Comments on #PSP-26-0004 - Planning & Zoning: Preliminary Subdivision Plat

Application Number: #PSP-26-0004
Application Type: Preliminary Subdivision Plat
Date: September 14, 2026
Address: 408 E YOUNG ST, ROLESVILLE, NC 27571
Parcel: 1768098727

Rolesville Town Campus

PRELIMINARY SUBDIVISION PLAT - SUBMITTAL #1

C-3.01

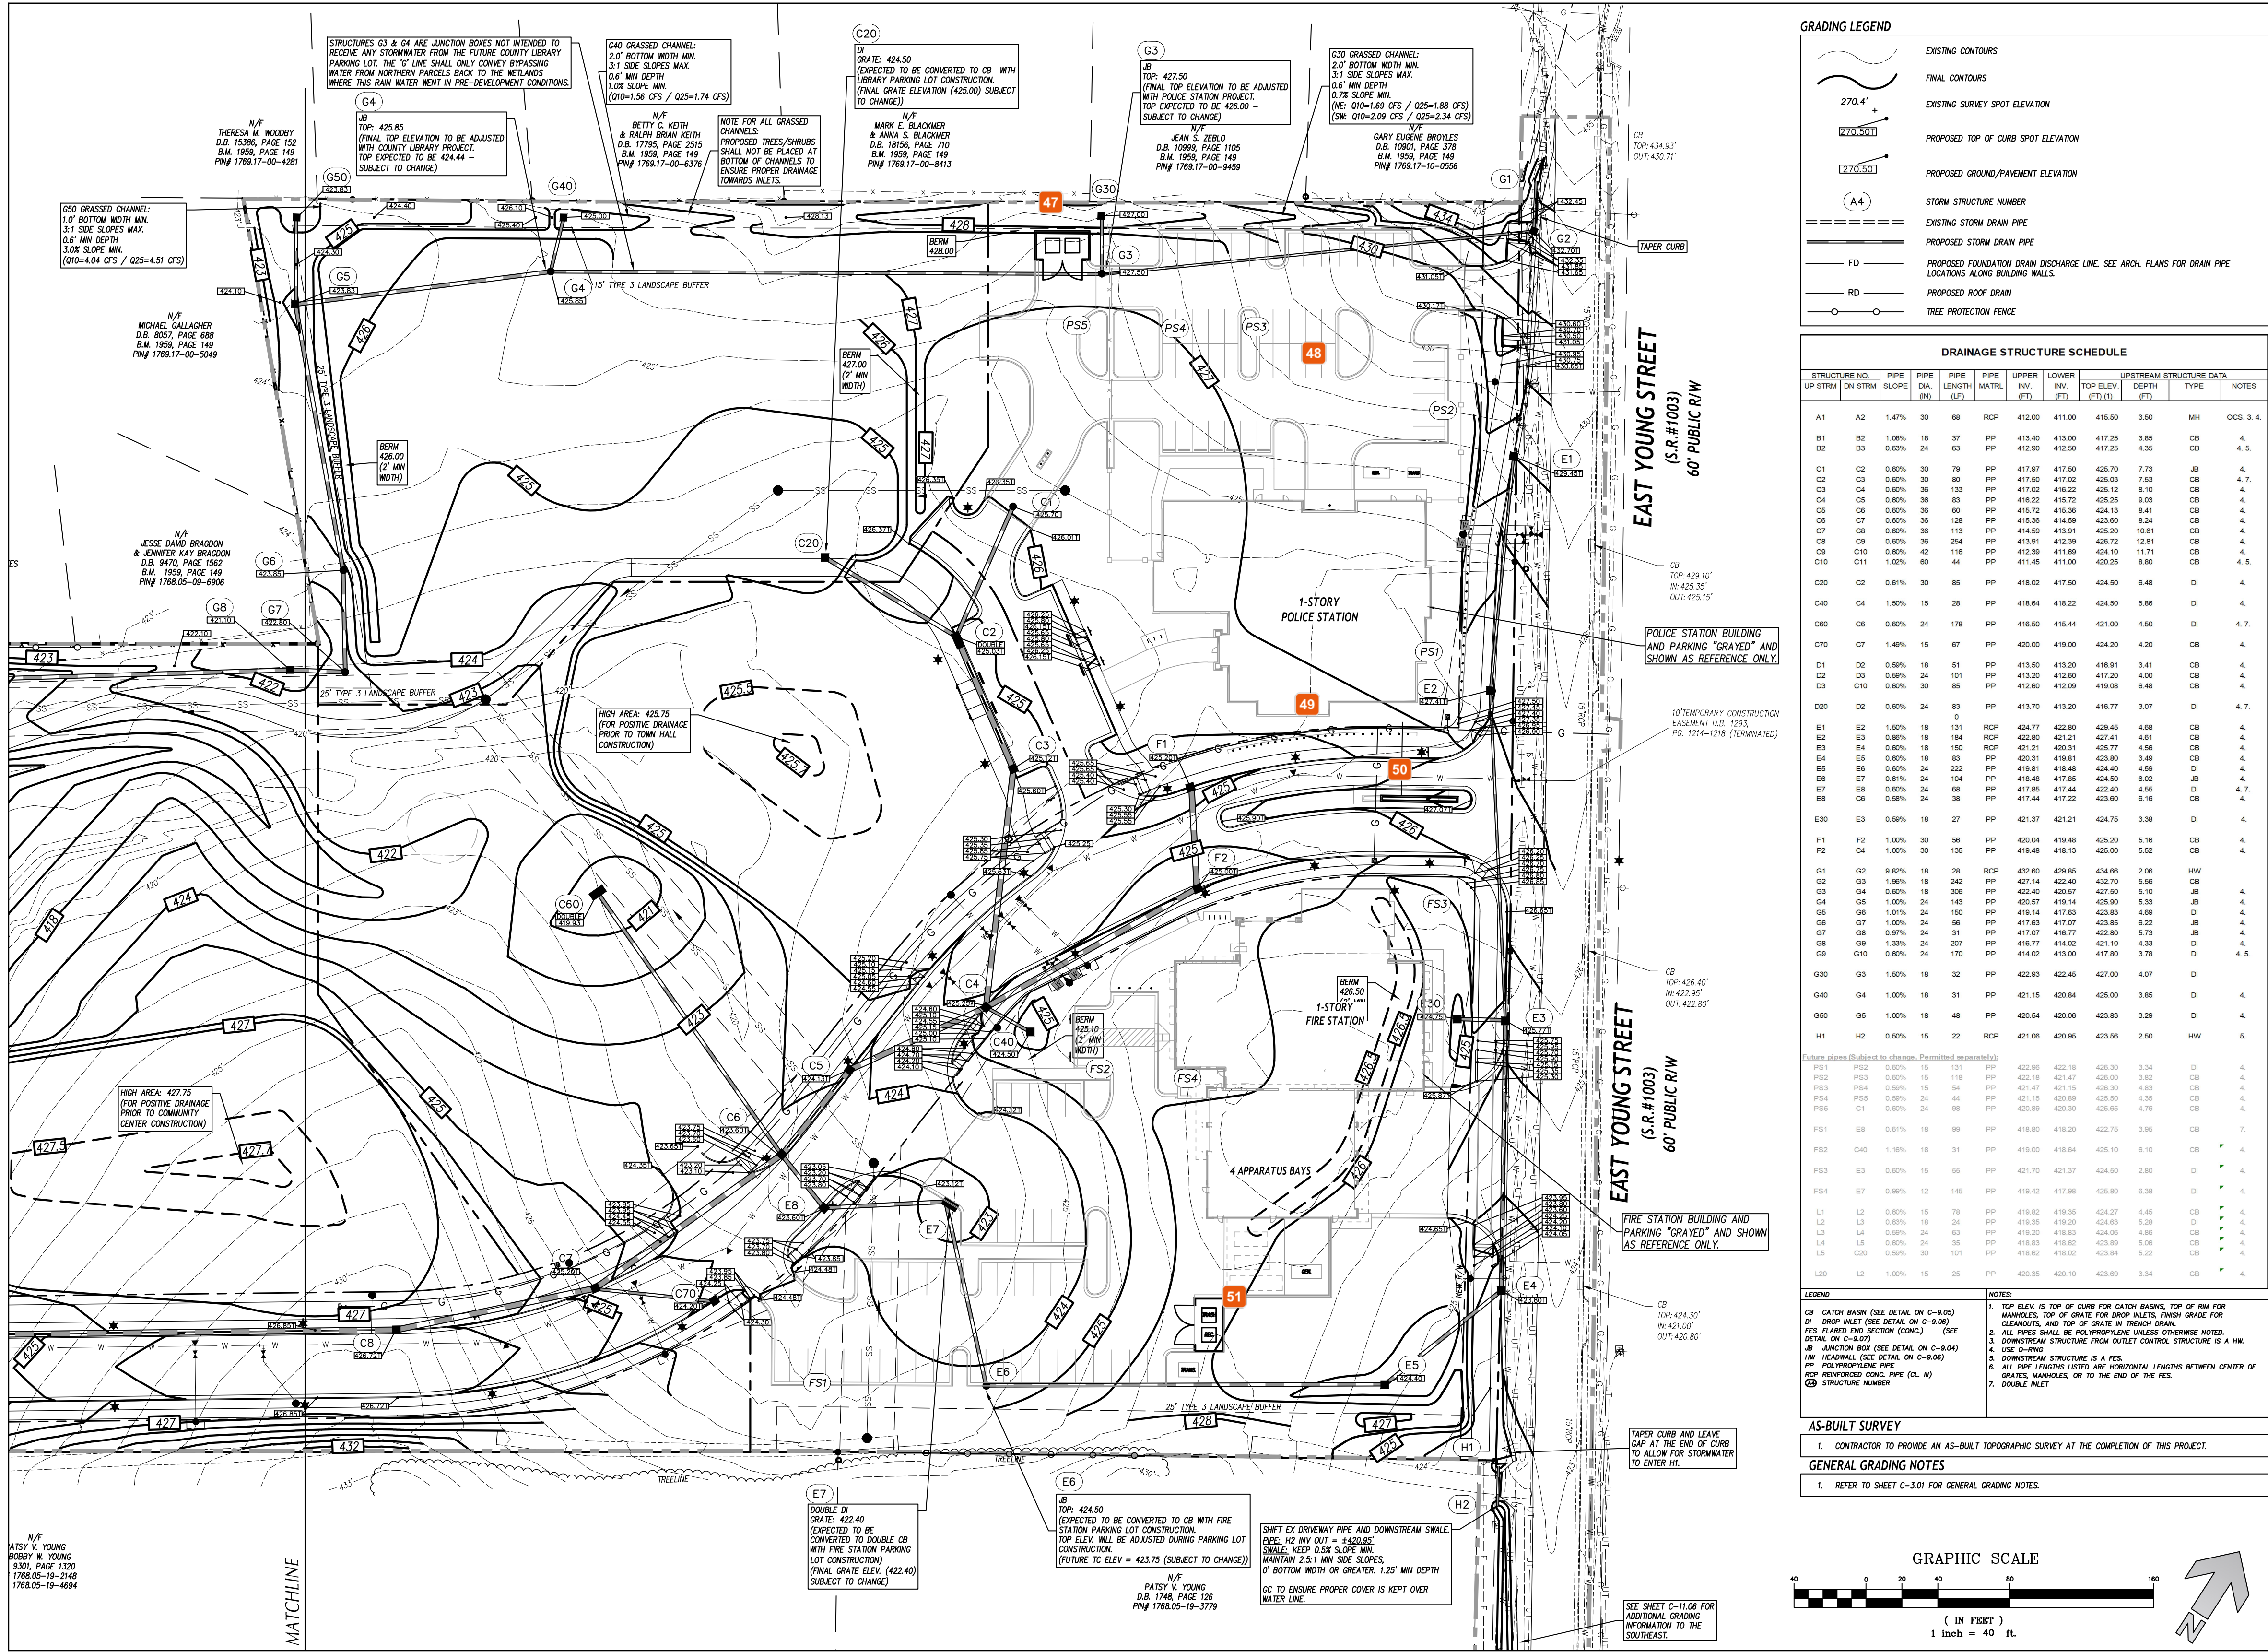
45 Jacqueline Thompson
The Town Standards Manual requires a 2' shoulder for the greenway section. Please ensure the shoulder is reflected in the grading plan.

46 Jacqueline Thompson
There doesn't appear to be a typical roadway or greenway section(s) included in the plans. Please add typical sections.

C-5.01

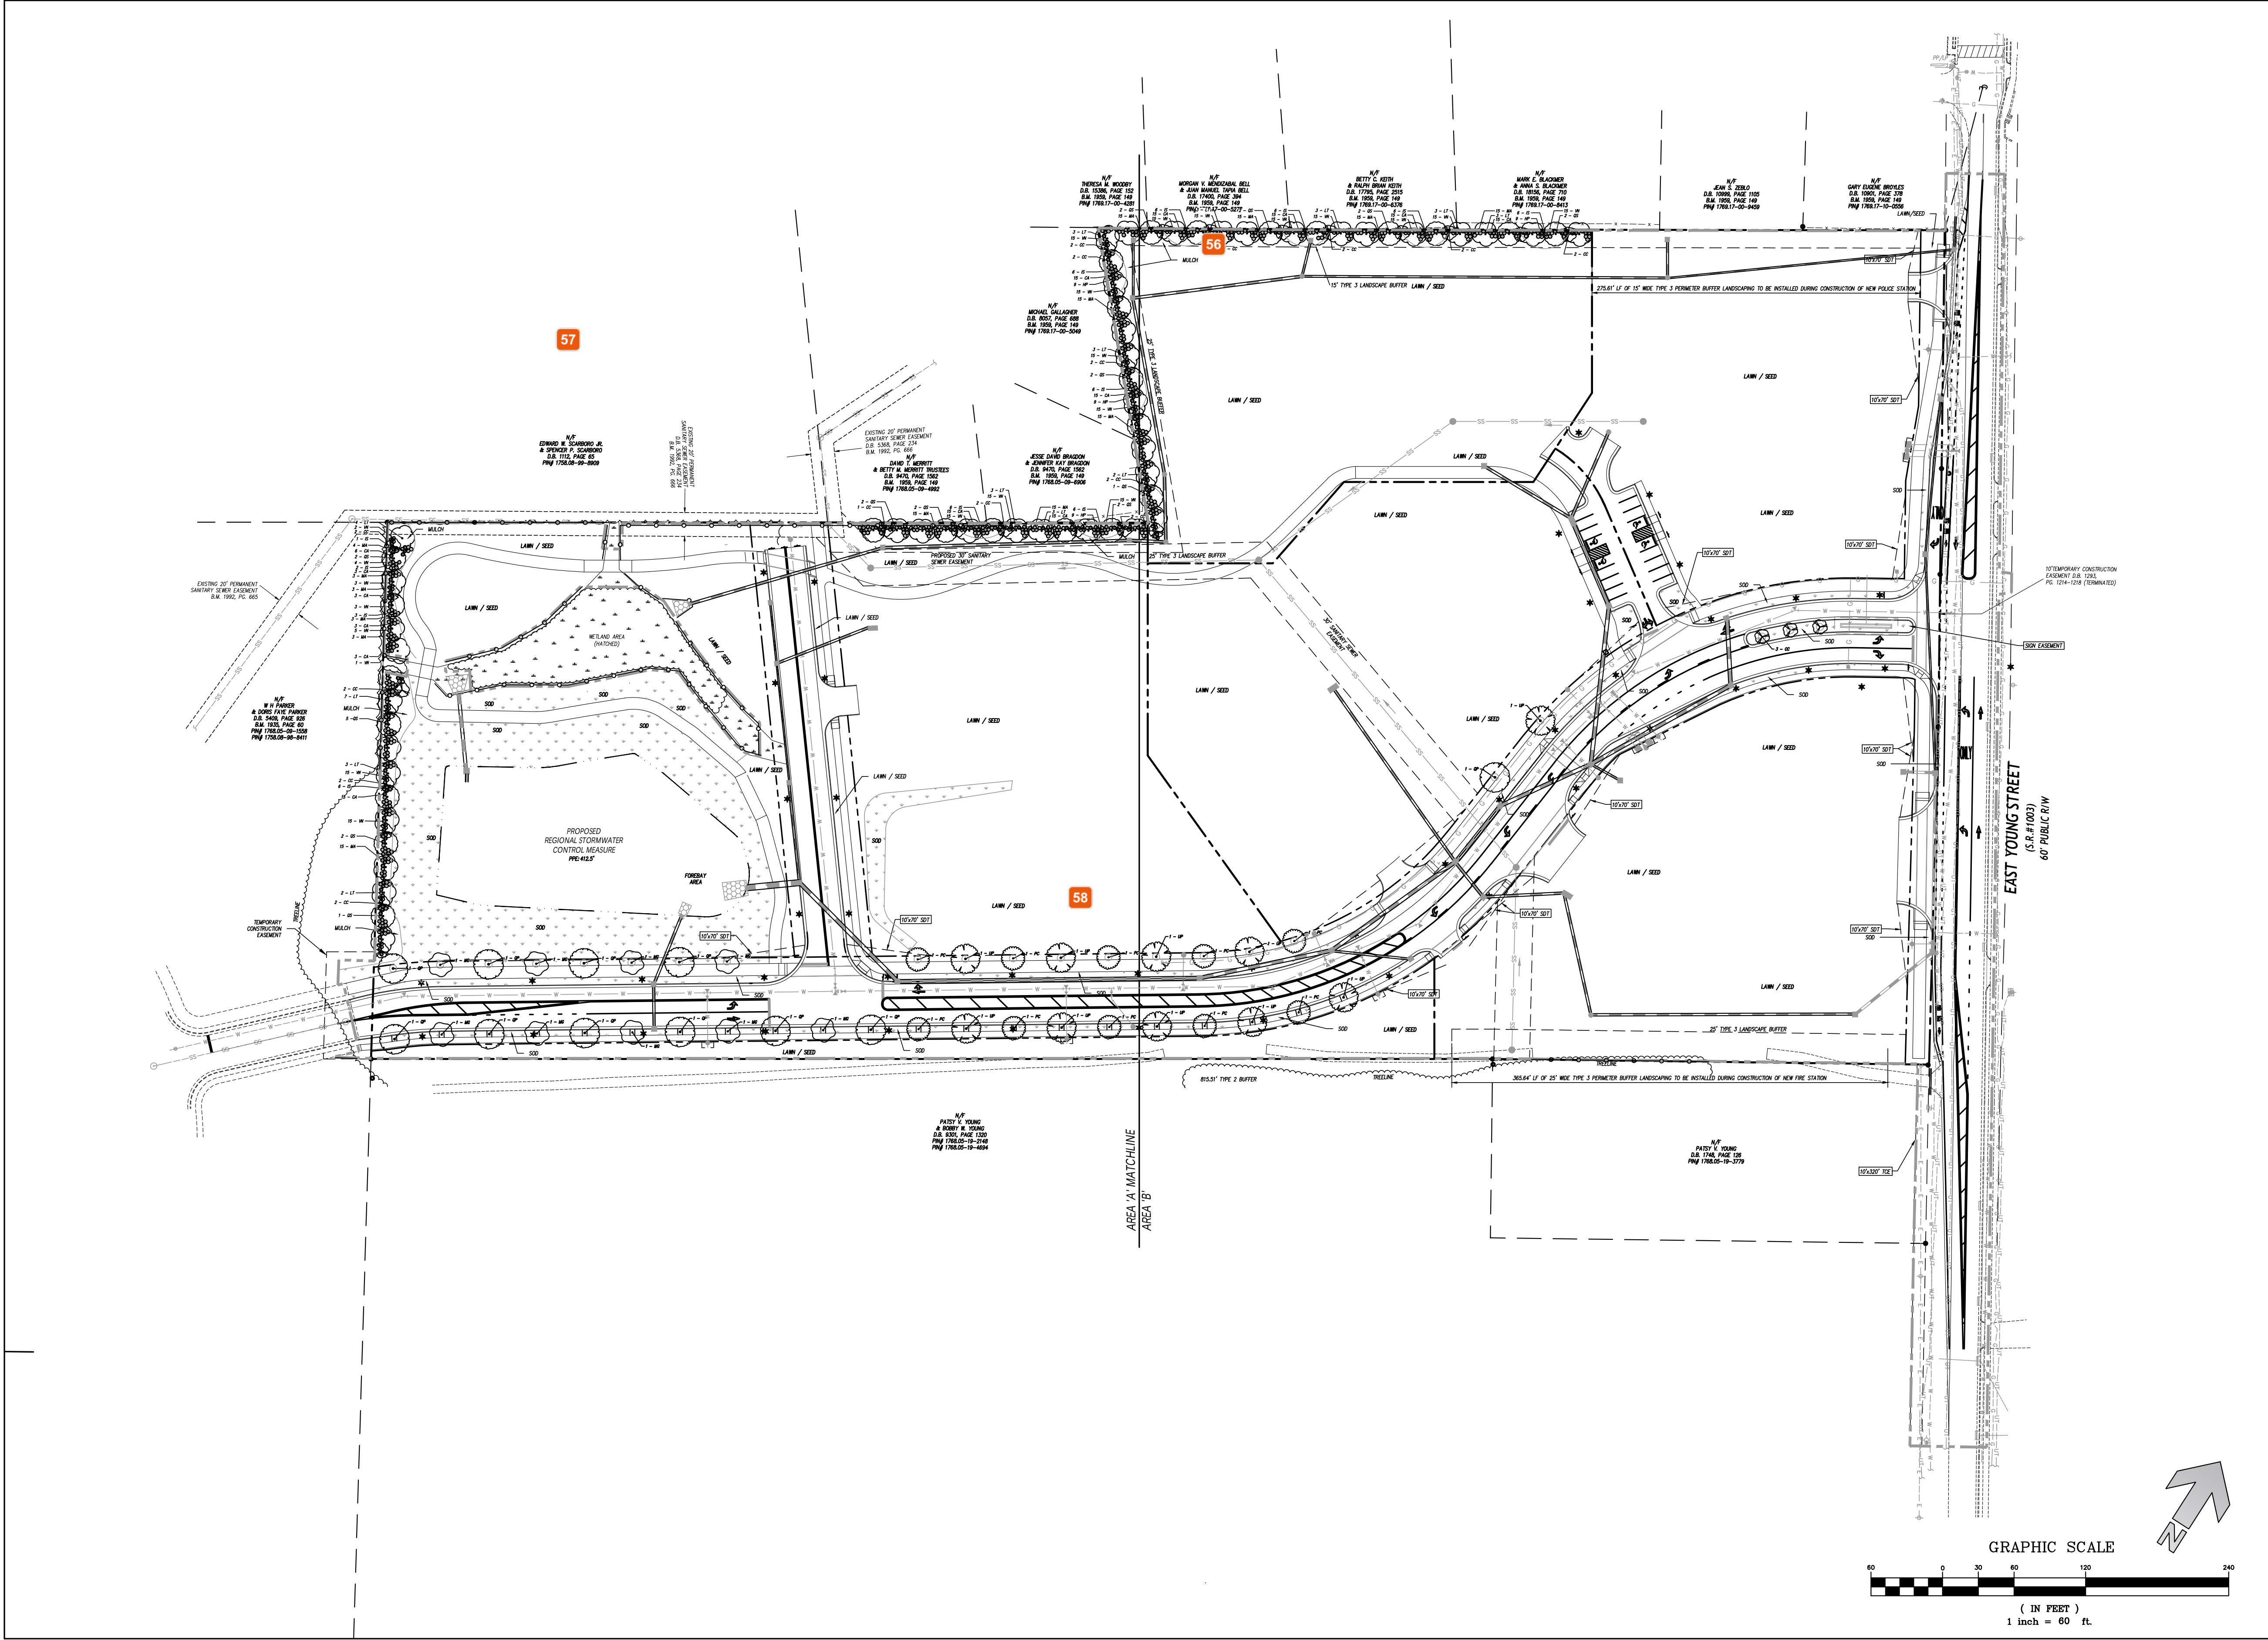
Light Pole, Utility Pole - that is usually CID level information Not PSP - also, the energy Provider typically dictates and provides Plans for those at or even after the CID phase.....this project may know this information due to the advancement of the CID before this PSP, so if that is the case, no harm if it remains. But normally this would be cart/horse info on a PSP.

Again, these notes are level of detail of CID.

55 Michael Elabarger
Again, these notes are level of detail of CID
